566 COLUMBUS AVE., BOSTON SOUTH END LANDMARK DISTRICT COMMISSION

18 MAY 2020

DESIGN REFINEMENTS BASED ON LANDMARKS AND BDPA JOINT DESIGN REVIEWS AND COMMUNITY INPUT:

BEFORE
(JAN 7, 2020 LANDMARKS DESIGN REVIEW)

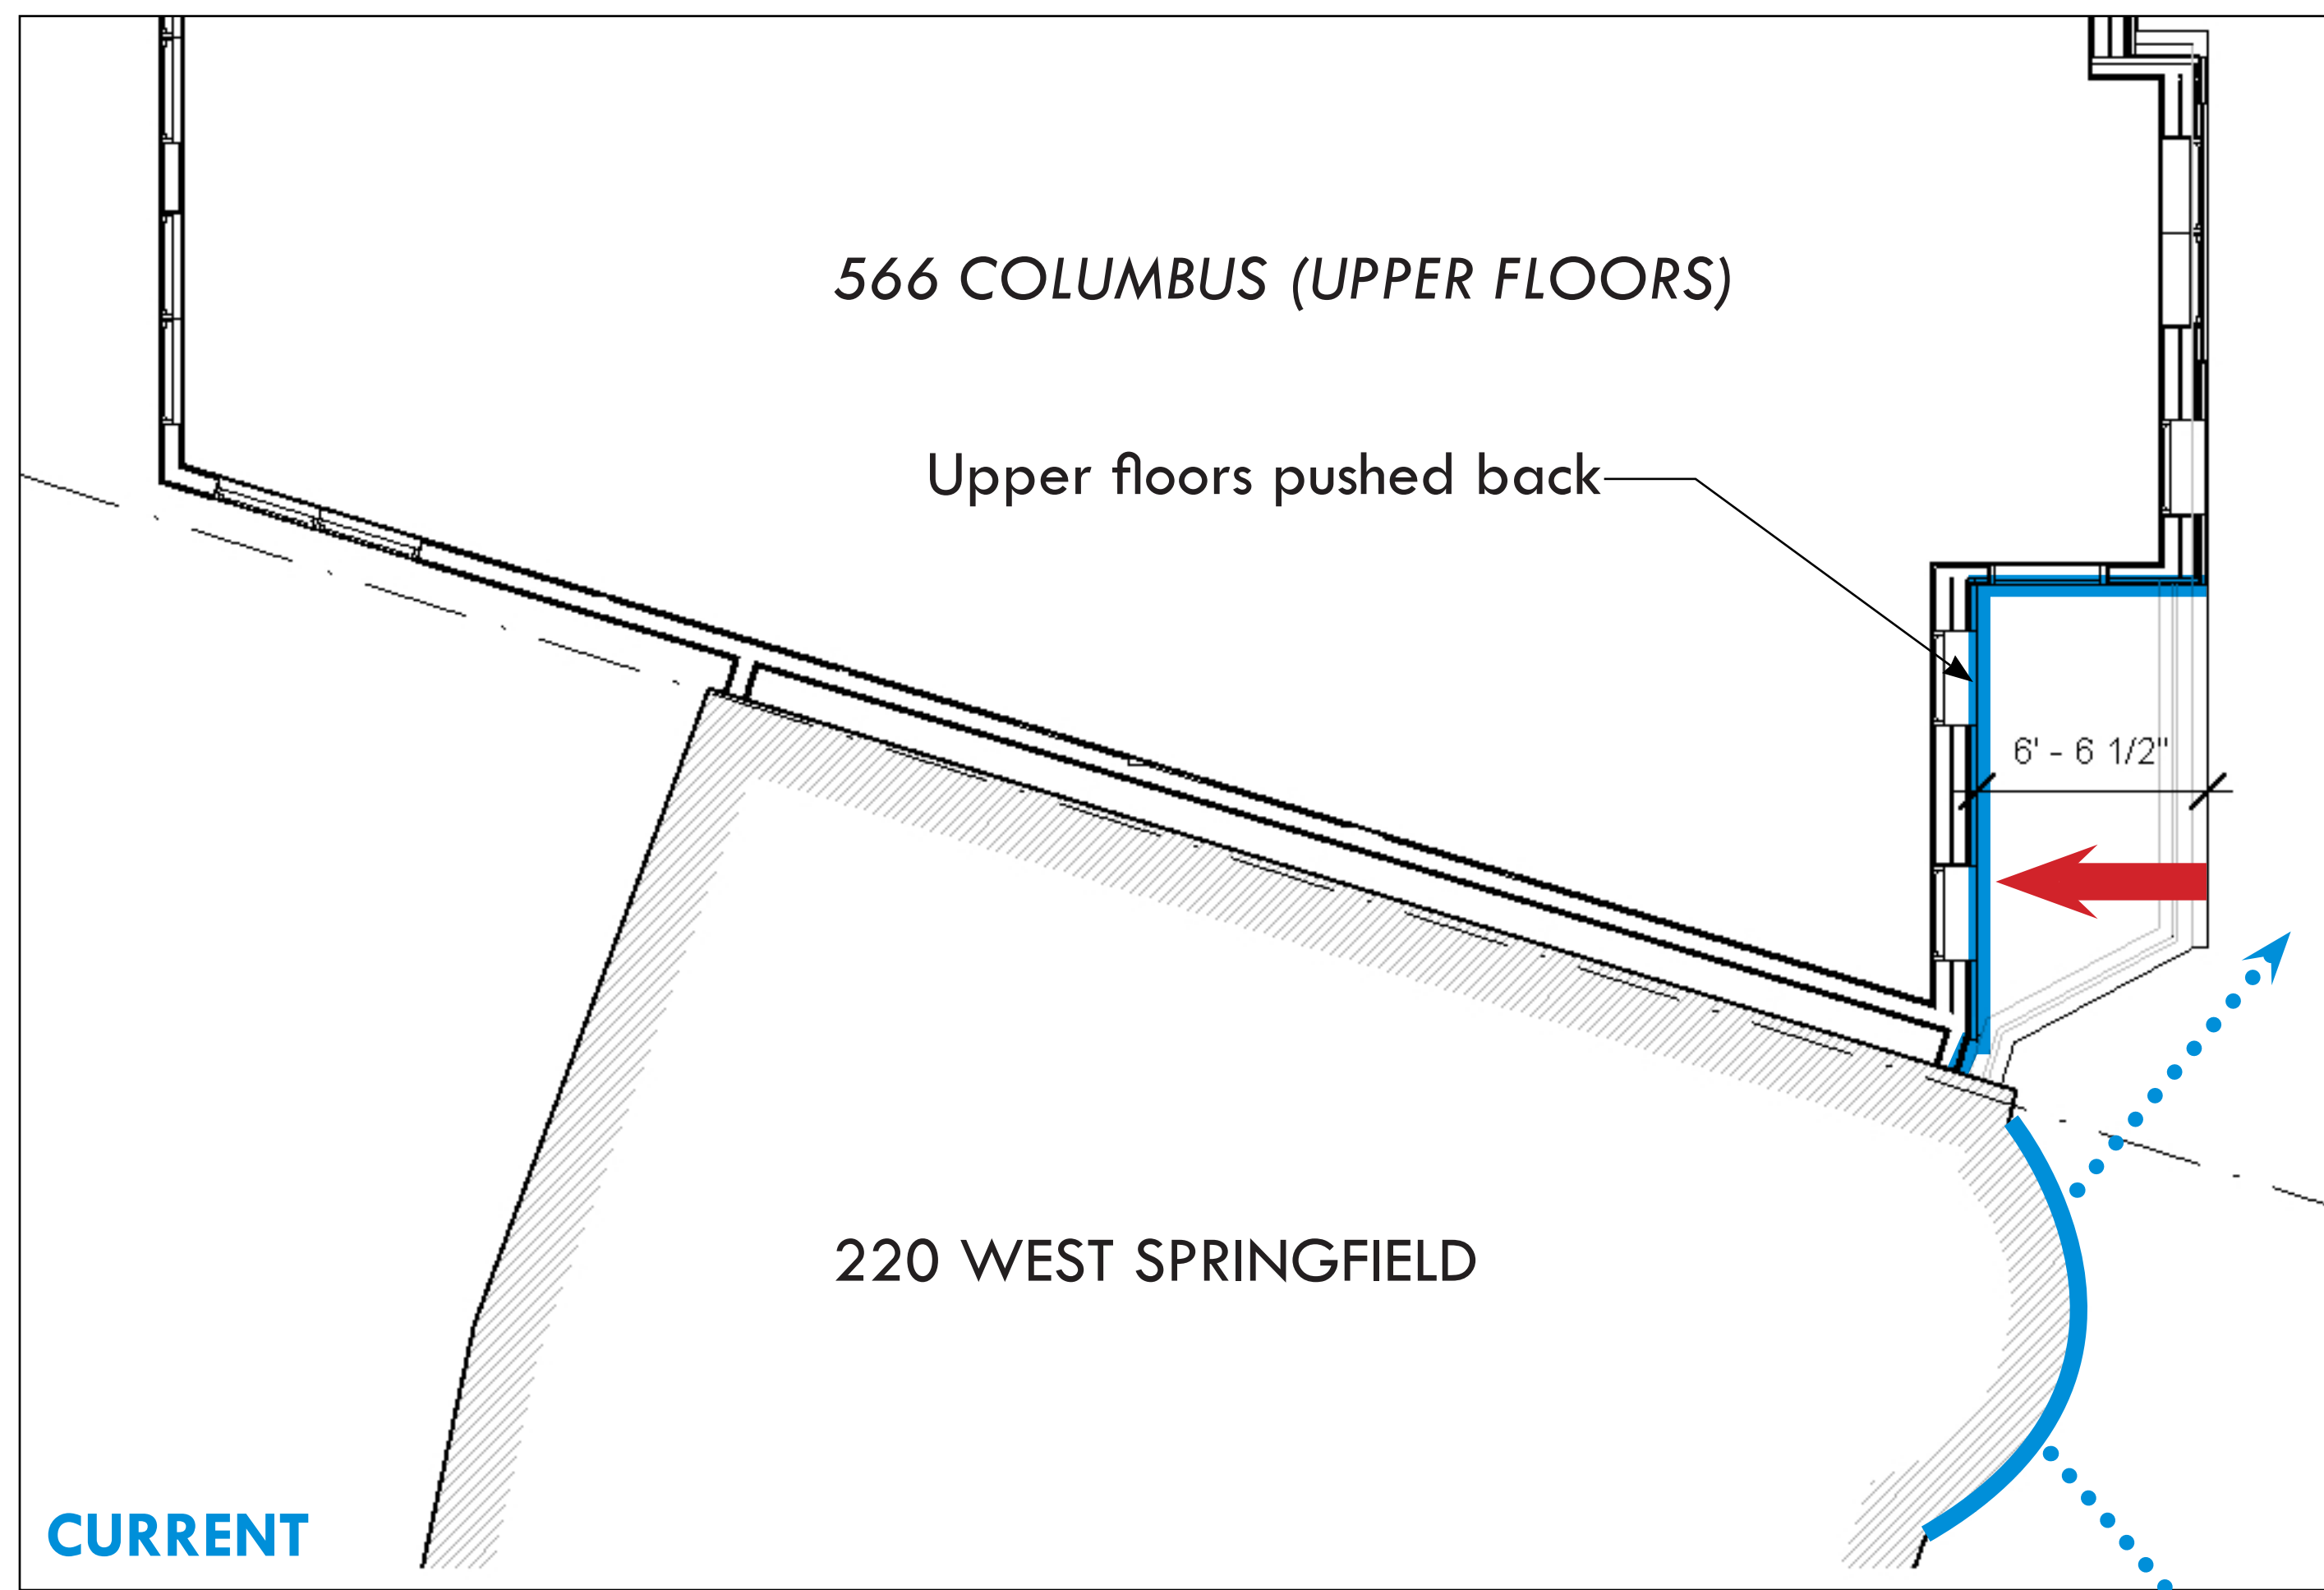
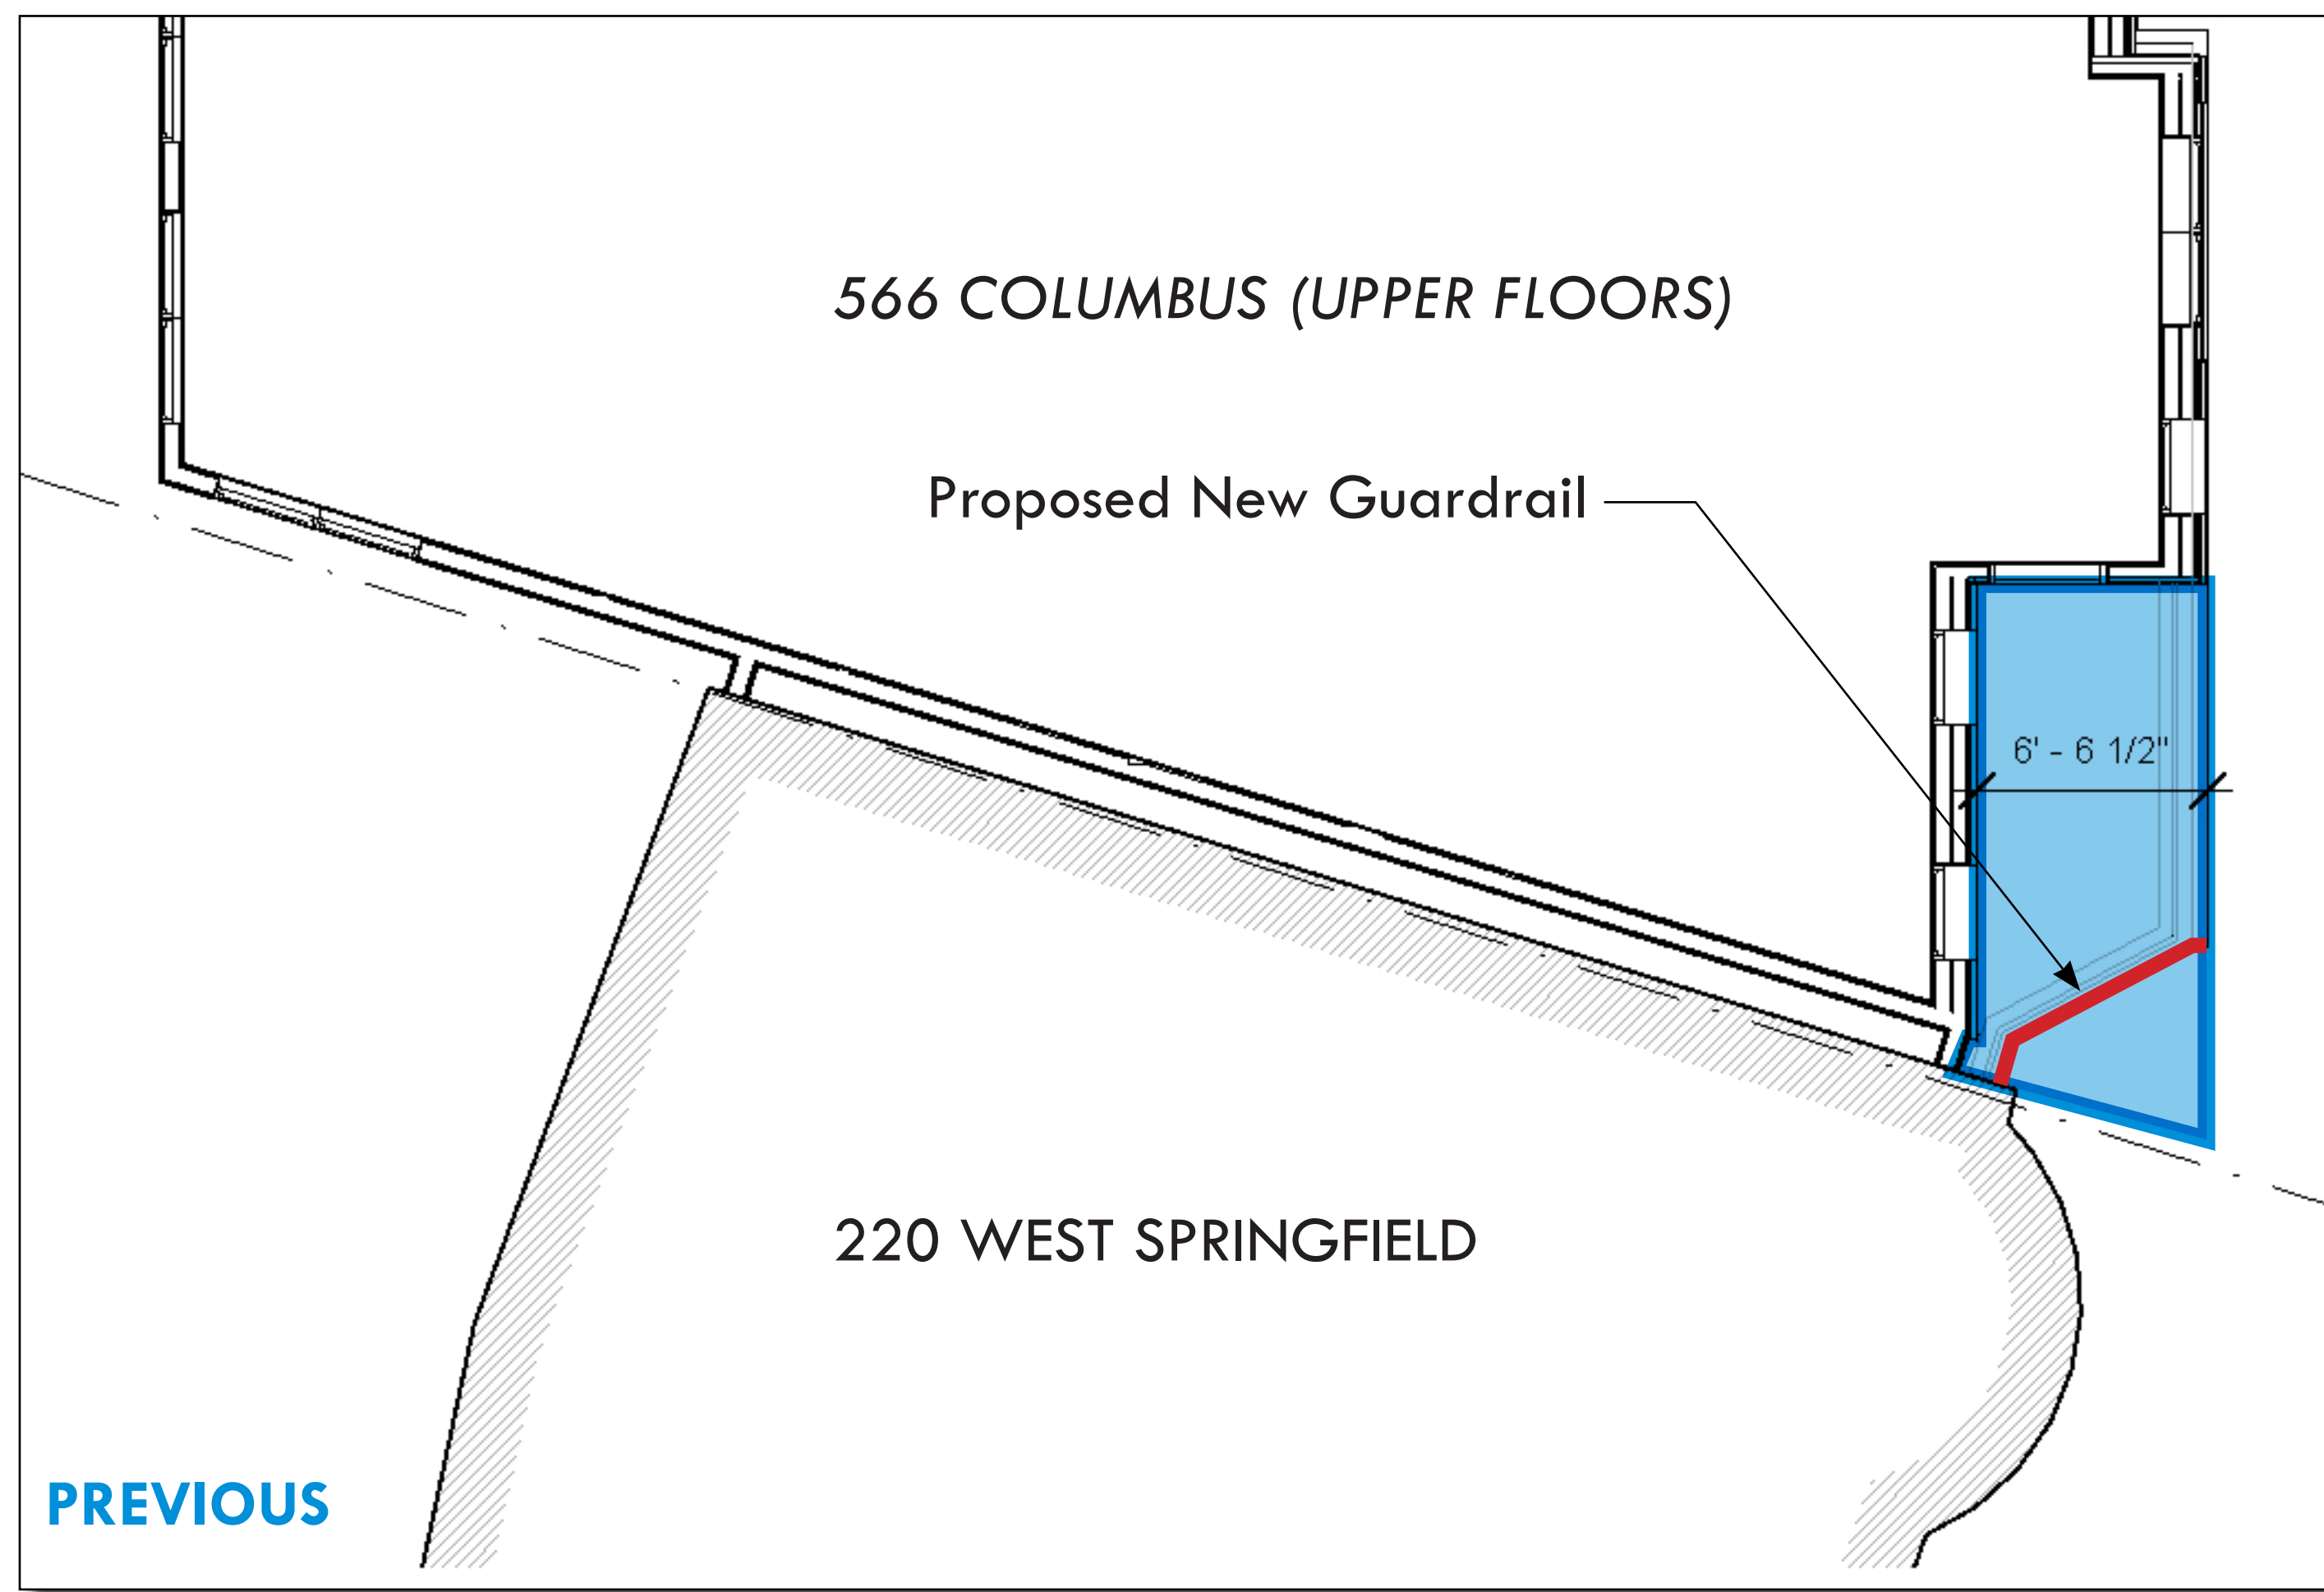
- Picket railings appear more exposed at attic story
- Two-tone fiber cement cladding material requires further study for District compatibility
- Metal cladding between windows appears random and inconsistent
- Juliet balconies extend beyond the building facade with randomized arrangement
- Metal clad detailing and proportions require further study and careful articulation
- Window types appear monolithic and inconsistent with the District. Openings, require further study and careful articulation
- Ground level entry conditions, delineation of commercial vs. residential, materiality and integration with public realm/streetscape all require further study
- Garage door design and materiality appear inconsistent with the District

- Steel picket rail heights are substantially reduced and are consistent with the Architecture of the District
- Corbelled brick cornice establishes a consistent datum, creates a clear delineation between brick and metal cladding, and subdivides the massing into "townhouse-like" proportions consistent with the Architecture of the District

- Anodized dark-bronze metal cladding defines the prominence of the corner and is carefully detailed with a nod toward the sense of depth, shadow, and sculpted "folds" and "pleats" consistent with the Architecture of the District

- Steel picket rails are captured within masonry openings and designed to be consistent with the Architecture of the District
- Red brick masonry cladding, detailing and articulation is designed to be consistent with the Architecture of the District

- Aluminum clad double-hung windows are designed to be consistent with the Architecture of the District, in color, frame profile and proportion
- Carriage style garage door detailing and articulation consistent with the Architecture of the District

- Granite base dimensions and proportions consistent with the Architecture of the District
